Midland 445 BT

Factory modifications:

Drawing 1

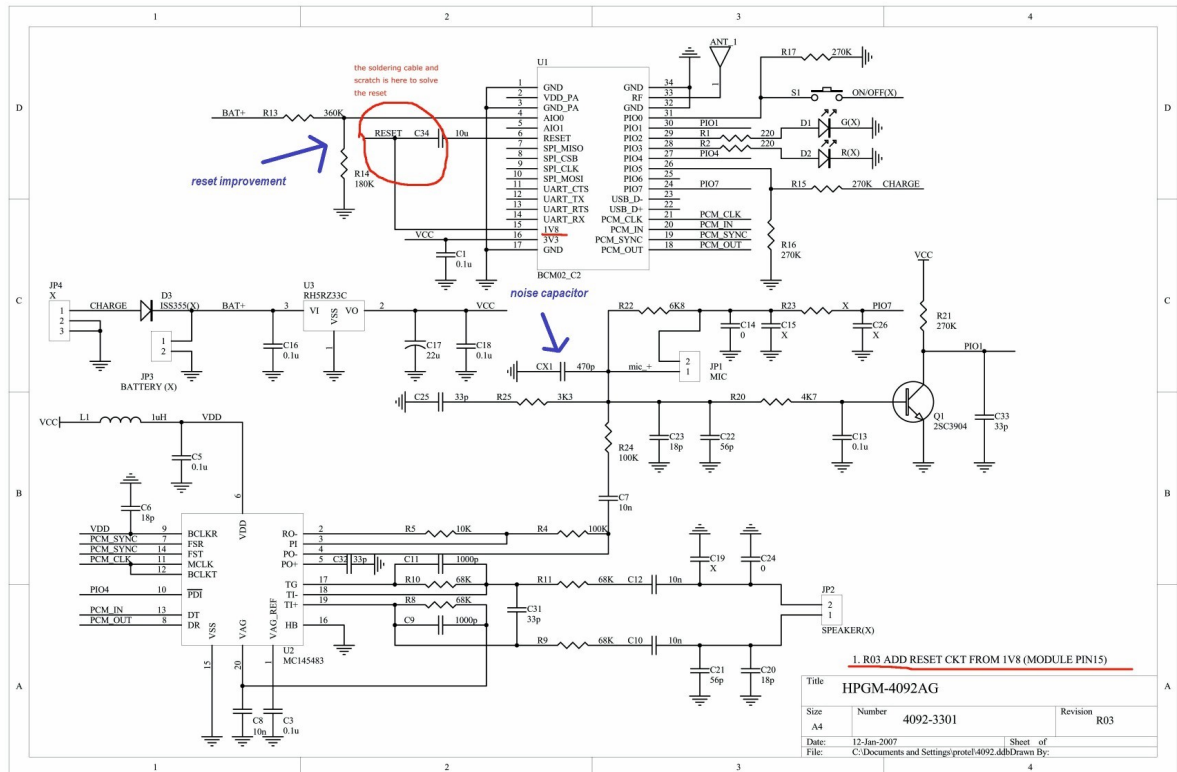
2. **The TX modulation in of the 445 BT in Bluetooth mode still produces some multiplexer noise in the background.**

To improve this problem, we delete R 22 (6.8 kOhm) from the Bluetooth Sub Board and insert 470 pF at the same position on the Bluetooth Board.

(see drawing 1 and drawing 2)

Drawing 2: Deleting 22 k and adding 470 pF on Bluetooth Board

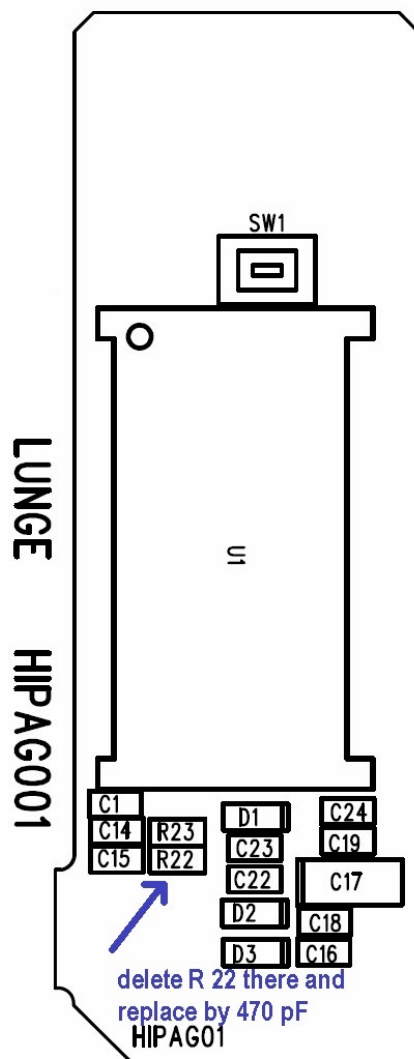
Please see the attached circuit diagram which shows the modification on RM 15 position in 445 BT radio main board.
